CHILDREN'S HOSPITAL  
OF ORANGE COUNTY

TOWER II

LEVEL 6 REFLECTED  
CEILING PLAN

A4.61

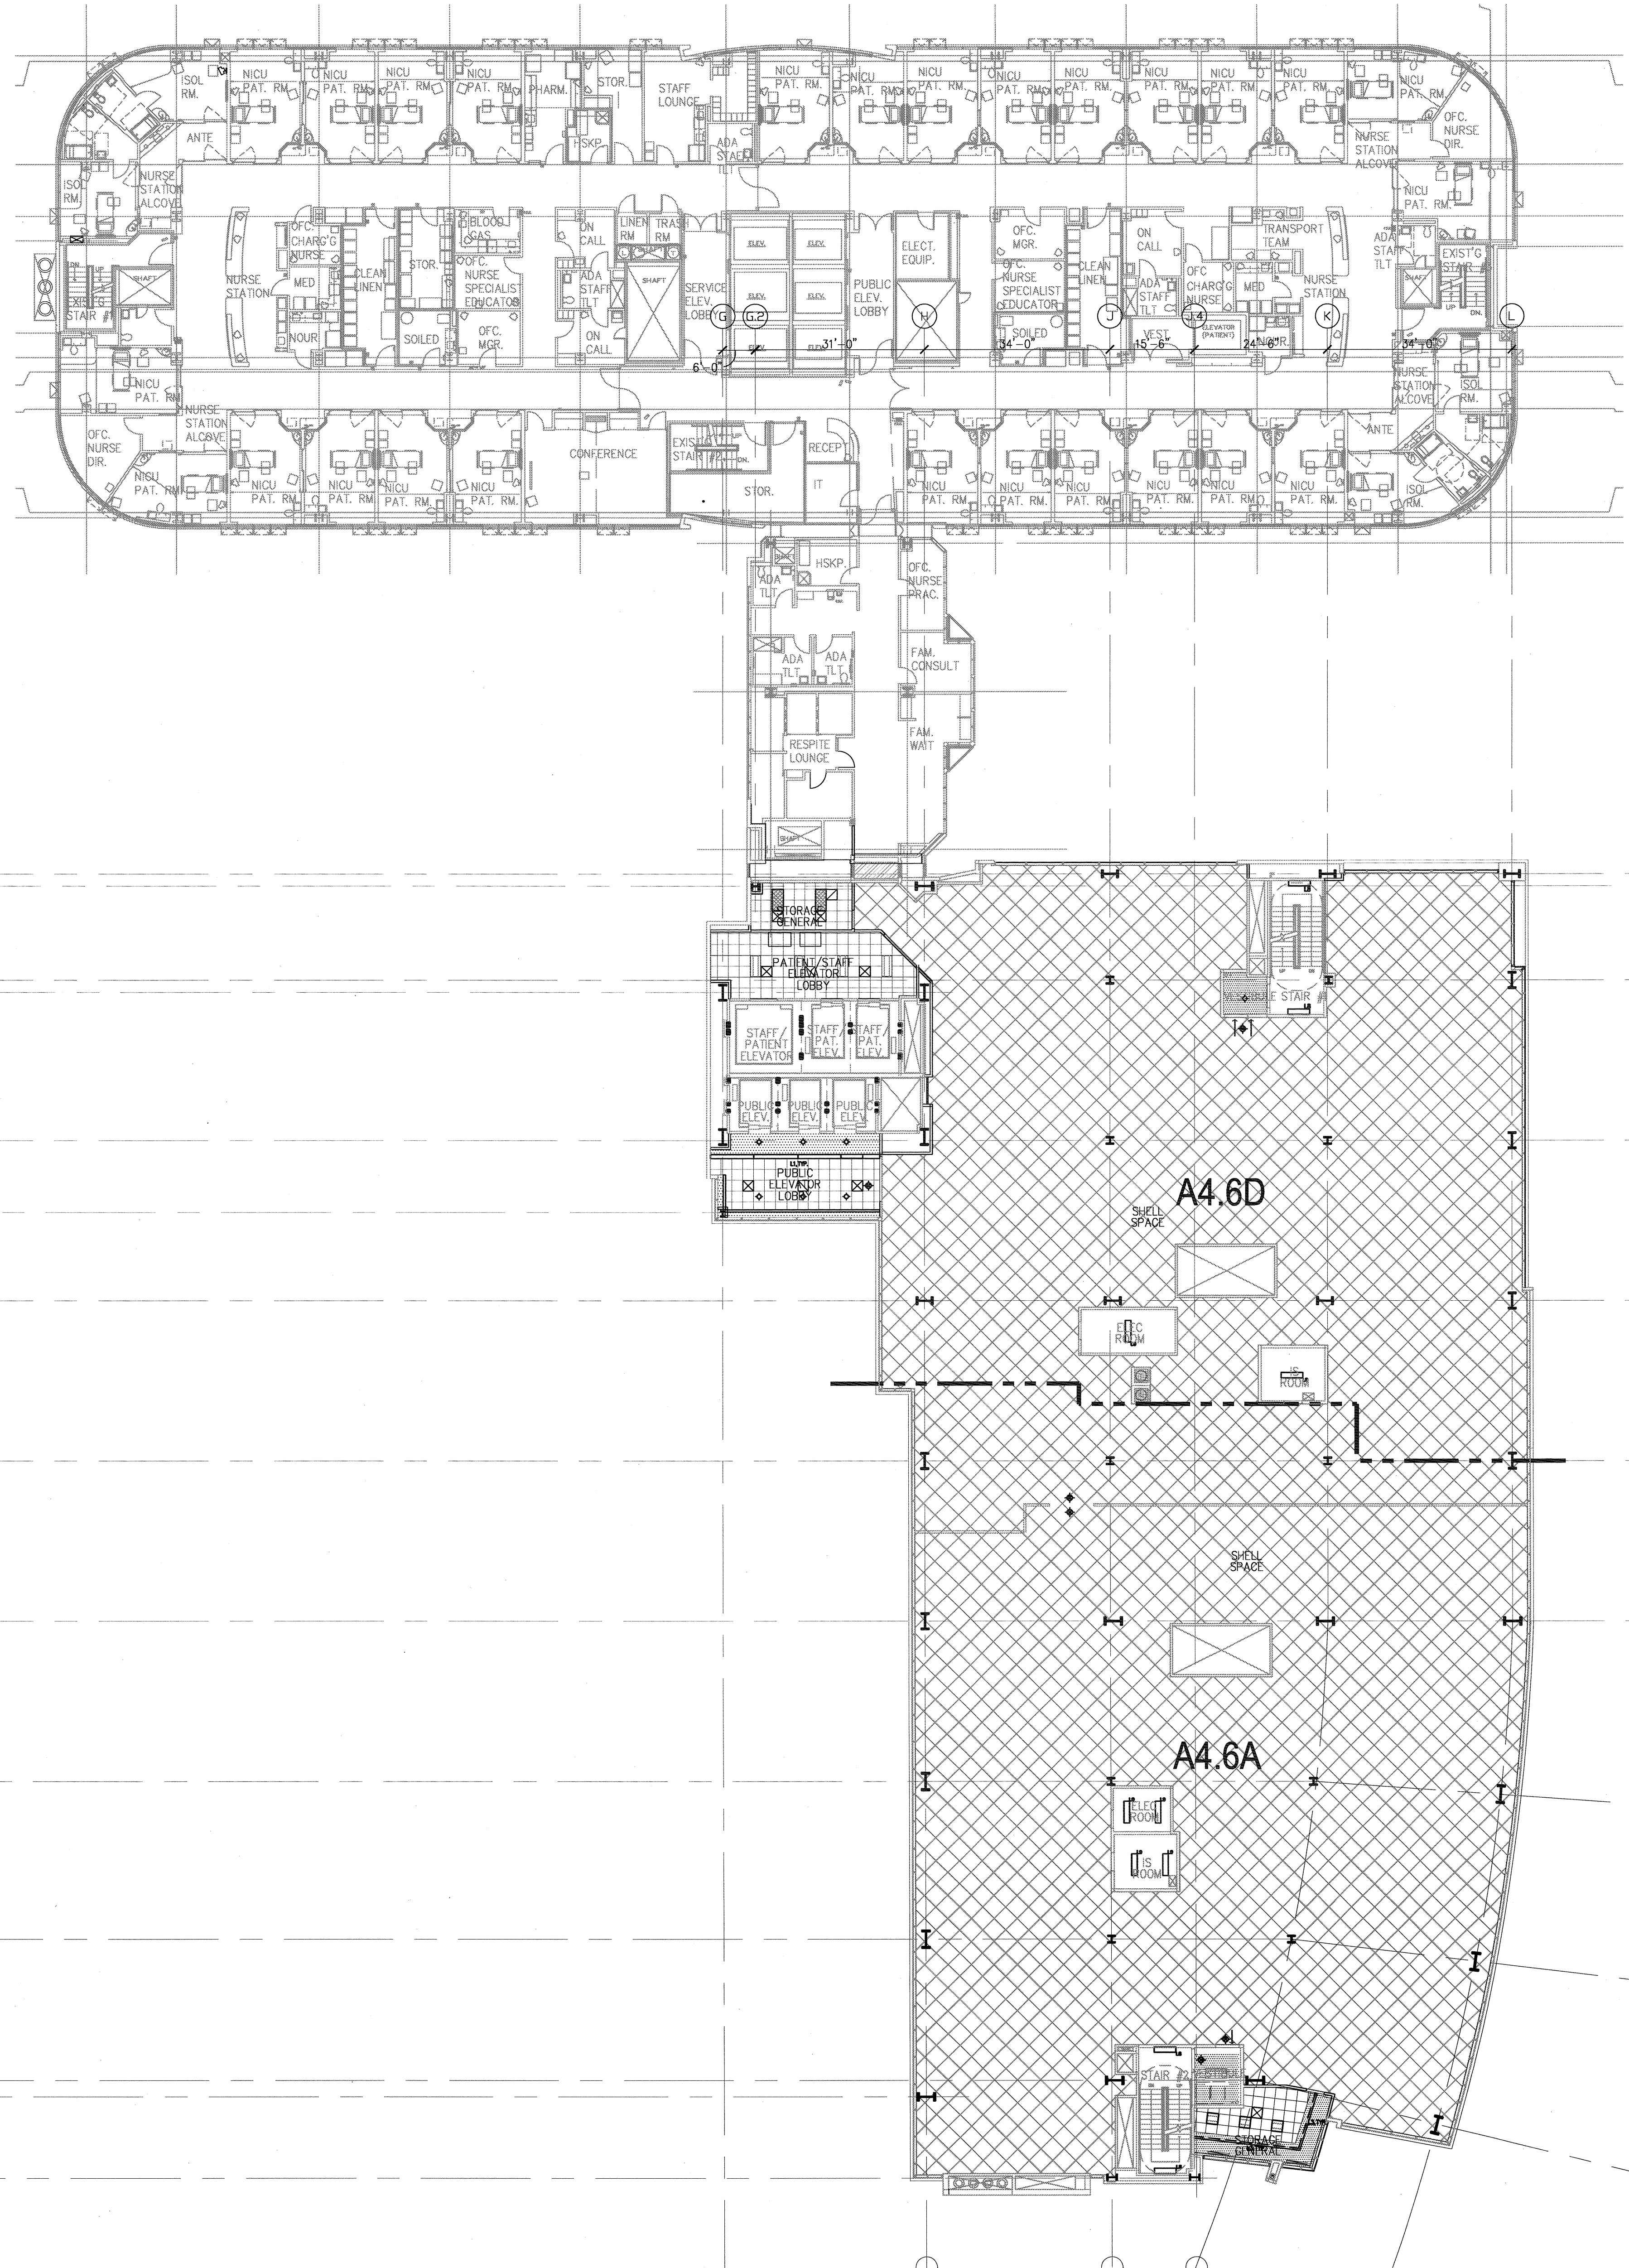
RFI 1018  
Refer to electrical lighting plans for  
light fixture locations in "shell space"
